DeltaPSU Product Notice

DRP024V240W1AA Product Upgrade Notice

PCN-21-001 Issue Date: 2021/02/01

Output Ratings / Characteristics

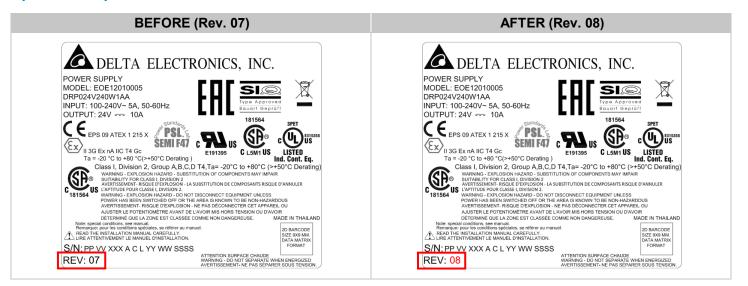
Due to end-of-life of certain key components, DRP024V240W1AA model will revise the output voltage adjust range from "22-28Vdc" to "24-28Vdc". The updated product datasheet and manual are available on <u>DeltaPSU</u> website.

Nominal Output Voltage	24Vdc
Output Voltage Tolerance	± 2% (initial set point tolerance from factory)
Output Voltage Adjustment Range	22-28Vdc
Output Current	10.0A (continuously operating at 24) 15.0A (Power Boost for 3 seconds at 24V, refer to the details in the Functions section)

Nominal Output Voltage	24Vdc
Output Voltage Tolerance	± 2% (initial set point tolerance from factory)
Output Voltage Adjustment Range	24-28Vdc
Output Current	10.0A (continuously operating at 24) 15.0A (Power Boost for 3 seconds at 24V, refer to the details in the Functions section)
